**Subject: PEABODY MIDWEST MINING, LLC (PMM)
Bear Run Mine (Amendment 5)
U.S. Army Corps of Engineers ID No. LRL-2011-1117-gjd
Response to July 19, 2012 USEPA Public Notice Comment Letter**

Enclosure 1 - Detailed EPA comments on the Section 404 Permit Application for Bear Run Mine Amendment 5

Photo 1: At CR 1100 South Bridge looking north at proposed location of SB067

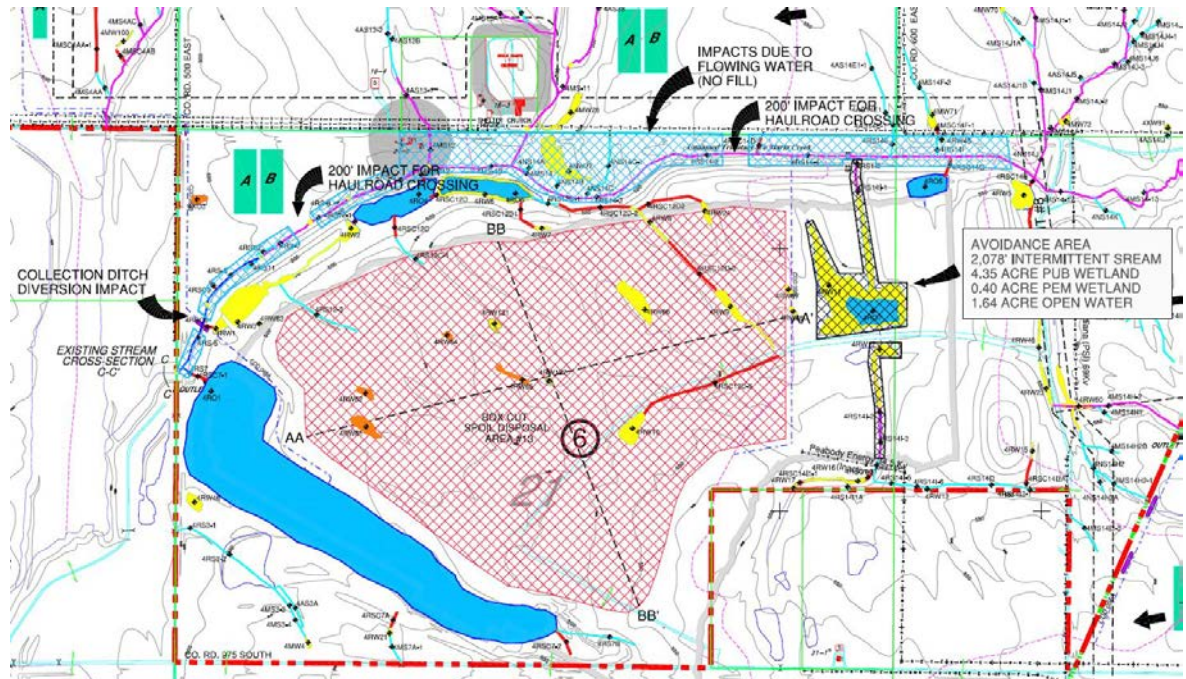
- Sediment control structures have been proposed within the stream channel, such as SB067. The 404 application does not explain why the applicant believes sediment control features need to be located in the channel as the existing topography would easily allow the structure to be excavated outside of jurisdictional waters. USEPA requests Peabody remove the sediment control

structure from the stream channel.

Response: Peabody has located SB067 as close to the coal removal area as possible to minimize disturbance on non-mining areas and to avoid additional disturbance downstream. This is the best practice when considering all mining, drainage control, and reclamation obligations. Locating the basin immediately adjacent to the mining area provides constant, effective drainage control for NPDES compliance, as opposed to a mine through and replace scenario. Also, the existing topography does not allow the structure to easily be constructed outside of the jurisdictional waters. The topography shows the excavation would need to occur through the unconsolidated material and into consolidated rock in order to create the necessary compliance volume while reaching the needed pool elevation to receive run off from the watershed. Also, Peabody believes the best plan for completing mitigation would be to connect the upstream mitigation to existing bridge at County Road 1100 south, as opposed to a connection to the existing narrow floodplain or entrenched stream 500 feet further north. Photos taken 07/23/12 from the bridge at CR 1100 south looking north and looking south are provided below.

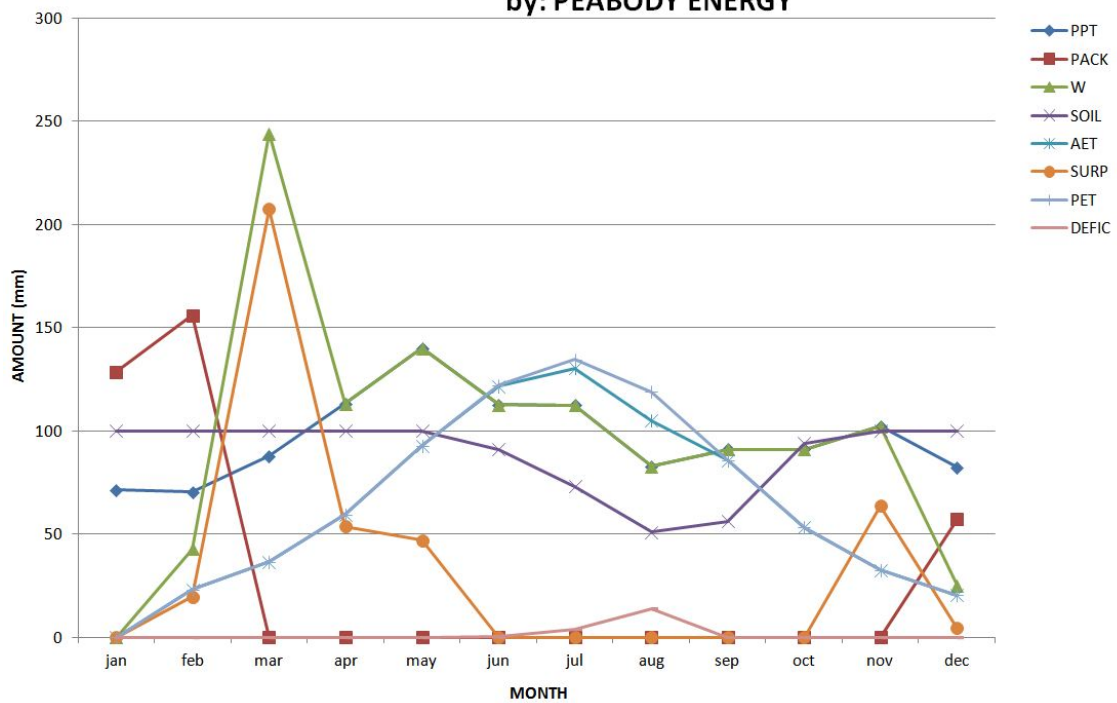
- The SMCRA application indicates buffer zones around various properties and cemeteries within the proposed mining area. It is not clear if these controlling structures have been reflected in the post mining topography or what impact they might have on the stream reconstruction. Peabody should specifically identify these features on the post mining contour and mitigation map.

Response: Any drainage control points will be considered in the post mine topography plan and will be blended appropriately. Peabody intends to pursue relocation of small abandoned cemeteries if the proper consents and approvals are obtained as required by Indiana law. Typically, abandoned cemetery plots are relocated to larger cemeteries where appropriate care and maintenance is provided. Other cemeteries will be mined around and reclaimed as previously discussed.
